Subject: Quad Cities Nuclear Power Station Unit 1 and 2
Review of Fire Protection Requirements
NRC Docket Nos. 50-254 and 50/265

ATTACHMENT

QUAD CITIES DISCREPANCIES
REQUEST RELIEF FROM COMMITMENT

FIGURE 1

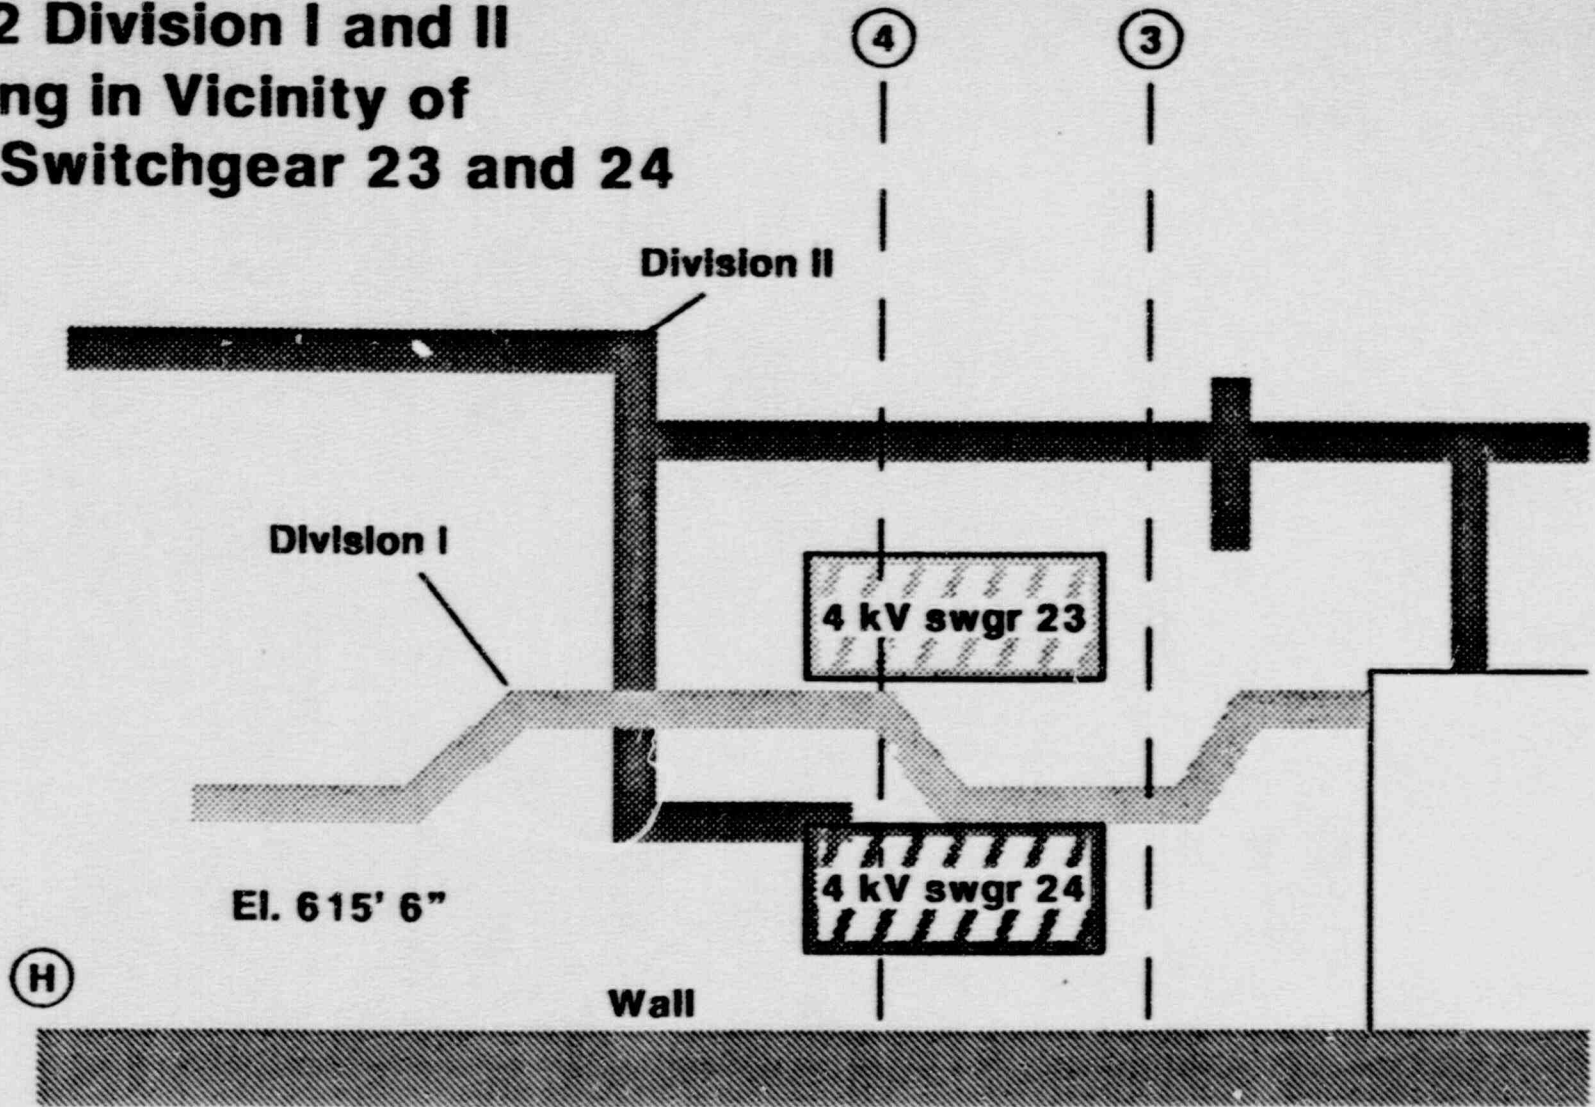
1.2	3.1.9	<p>SER Section 3.1.9 states, "Where cable trays of different divisions are closer than 3 feet horizontally or 5 feet vertically from each other" the cables will be protected with a flame retardent barrier. Five areas at Quad Cities Station exist which do not meet the above separation criteria. It is important to note that at the time of the Quad Cities FP SER, 10 CFR 50, Appendix R was being issued which outlined new separation criteria.</p> <p>In July 1978, CECO submitted a Safe Shutdown Analysis showing that Quad Cities could be safely shutdown using the RCIC system for reactor water makeup. In supplements dated September 1979 and January 1980, further information was provided to show that both hot and cold shutdown could be achieved. However, these analysis did not fully comply with the staff requirements in 10 CFR 50, Appendix R and NRR Staff Position (Generic Letter 81-12) on safe shutdown. These subsequent NRC requirements were addressed in the 1982 Associated Circuits report. Further clarifications (Generic Letter 83-33) of these requirements were addressed in the Quad Cities Station Exemption Requests submittal dated December 19, 1984. The coating of redundant safety related cables was not required to achieve separation to ensure safe shutdown in the event of a fire by any of these analyses. Based on Quad Cities compliance with the new separation criteria outlined in 10 CFR 50, Appendix R, relief from this commitment is requested.</p> <p>Interim Action: Temporary protective barriers have been installed where required.</p>
